City of Mississauga

City Department and Agency Comments

Date Finalized: 2025-08-21	File(s): A452.24
To: Committee of Adjustment	
From: Committee of Adjustment Coordinator	Meeting date:8/28/2025 1:00:00 PM

Property Address: 2210 Robin Dr

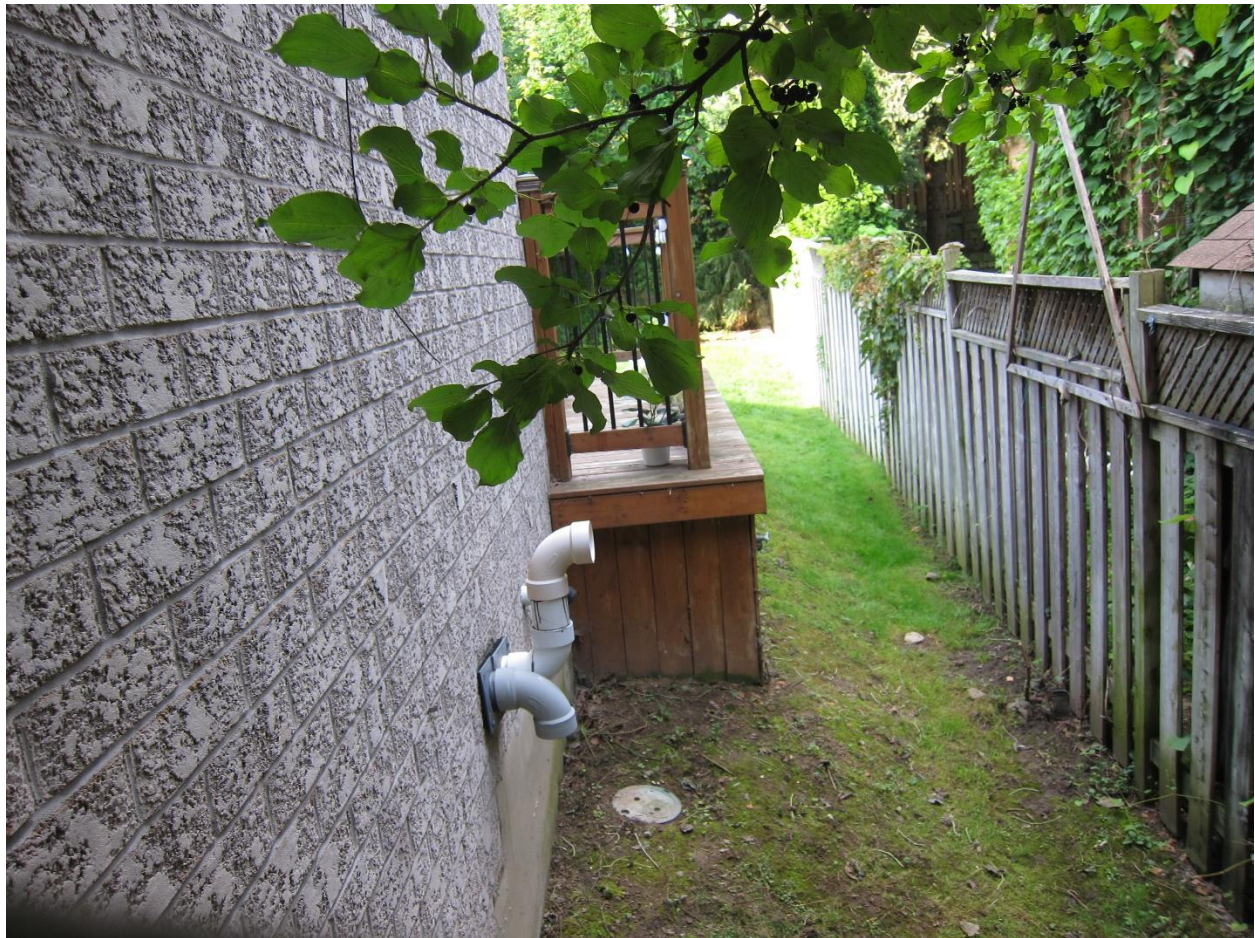
Enclosed are pictures of the property. We advise that our Development Construction Section has been on site through the review of SEC UNIT-24/5444 and have no drainage concerns.

However, our Traffic Planning Section does not recommend permitting a second access point or a driveway access width exceeding 8.5m.

Through Traffic Engineering best practices, driveway widths on the municipal road network are generally minimized to optimize roadway safety and efficiency, minimize vehicular and pedestrian conflict points, ensure sufficient space is available between driveways for signage/utilities/trees/other street appurtenances, maintain on-street parking spaces and clearly identify which property each driveway serves, etc.

Should the Committee see merit in approving the requested minor variance, the applicant is advised that all costs incurred in providing any new driveway entrances to the subject lands or any modifications/reinstatement required (including the existing driveway), would be at the cost of the owner. We are also noting that should any utilities/trees need to be relocated, all costs incurred will also be at the expense of the owner. Driveway accesses shall maintain a 1.5m setback from aboveground features such as utilities. Setbacks from any trees shall be confirmed with the City's Community Services Department. The applicant would also be required to apply for Access Modification Permits prior to Site Plan Approval and/or Building Permit Issuance.
